1992 Corvette: Service Bulletin: Brake Pedal Not Fully Returning / Stop Lights Stay On and/or Roughness/Vibration From Rear of Vehicle

Model and Year: 1992 CHEVROLET CORVETTE

Bulletin Number: 92-71A-5 - (01/31/1992)

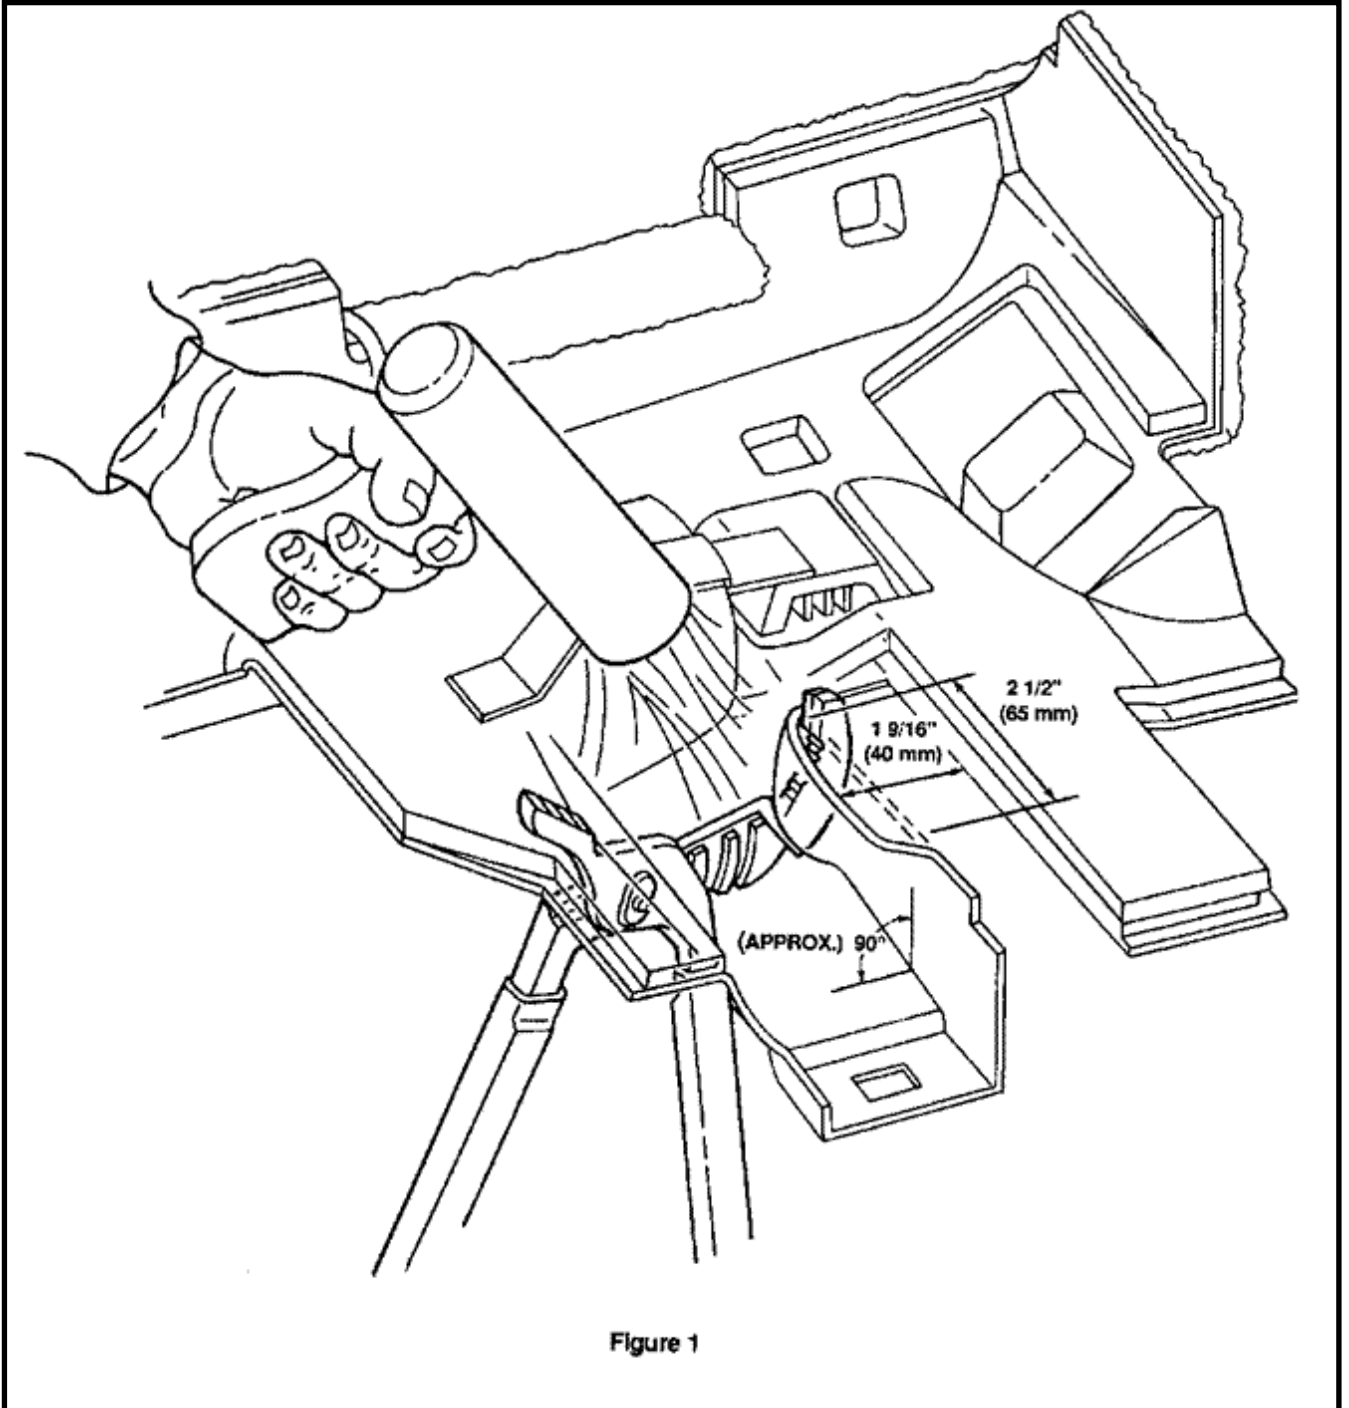
Some 1992 Y-car base Corvettes built from SOP to VIN breakpoint 104324 and ZR1's built from SOP to VIN breakpoint 800193 may exhibit inadequate clearance between the brake service pedal arm and the I/P lower trim panel.

Determine if interference exists between brake pedal arm and I/P lower trim panel (a minimum clearance of 2mm (.080 in.) is required). To verify clearance, an item approximately 2mm thick, such as a 2mm shim, should pass between the trim panel and pedal arm on both sides. If there is clearance, diagnose concern per Service Manual, Section 5-3. If the minimum clearance does not exist, perform the following steps:

1. Remove LH lower trim panel (per Service Manual, Section 8C-33).
2. Lift away the foam sound deadener from area shown in Figure #1, and tape out of the way.
3. Using a heat gun, warm the trim panel area shown in Figure #1 (USE CARE TO WARM COMPLETE AREA EVENLY).
4. Using Channel Locks (R) size 16 or larger, place near the upper LH corner of the I/P lower trim panel as shown in Figure 1. Quickly reform the brake pedal opening to configuration and dimensions indicated in illustration. If necessary Channel Locks may be moved downward during initial reforming and/or Steps 3 and 4 may be repeated to obtain minimum clearance of 2mm between the brake service pedal arm and the I/P trim panel.

Note: To lessen Channel Lock imprint, place smooth shim stock or aluminum face cover between the Channel Lock face and the warmed surface on the trim panel.

5. Reinstall lower trim panel. Remeasure the clearance between trim panel and the brake pedal arm, using method stated in correction above.
6. If contact still exists, phone Action Center #1 -800-457-8388.
